SUBJECT: Approval of New System Variance Request, McCray property, 8 Rod Road, Augusta

NEW SYSTEM VARIANCE REQUEST

SUBSURFACE WASTEWATER DISPOSAL SYSTEM APPLICATION

SUBSURFACE WASTEWATER DISPOSAL PLAN

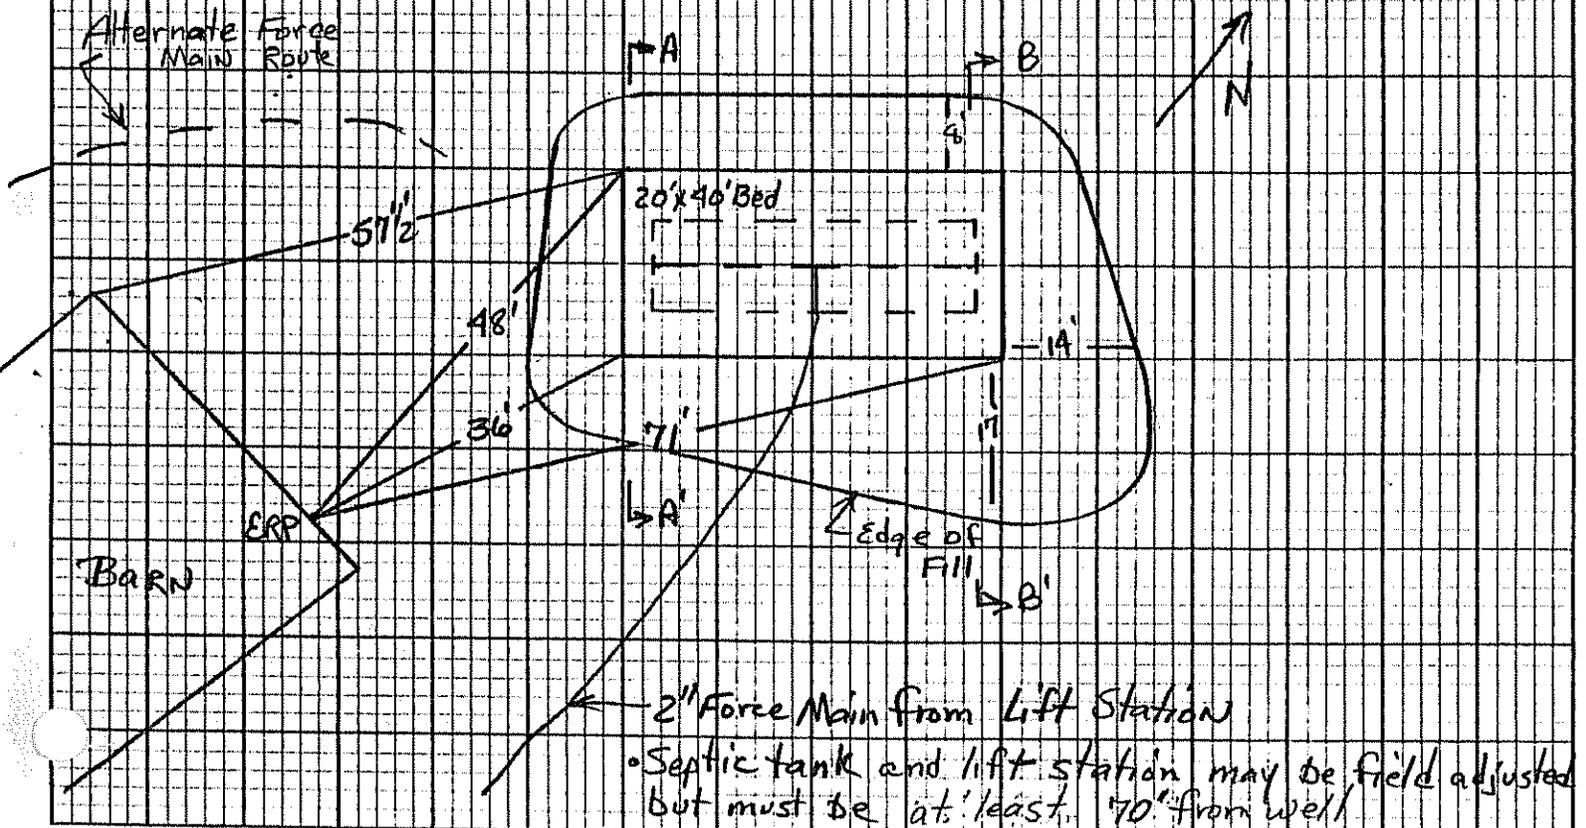
To allow a disposal system to be installed 75 feet from an existing well.

The proposed location of the septic tank and lift station should be approximately 70' from the owner's well to avoid excessive depth of the septic tank in a seasonally wet area. The septic tank will be tested for water-tightness in the presence of the LPI to ensure integrity of the septic tank. I believe that this will overcome the site limitation.

The Division approves of the application dated 8/13/90 by William Brown, SE.

Mr. Brown shall be retained to establish the system location and elevation at the time of construction.

Gary Fuller, the Local Plumbing Inspector shall issue a permit prior to the system's installation. The system shall be constructed in compliance with the submitted application.
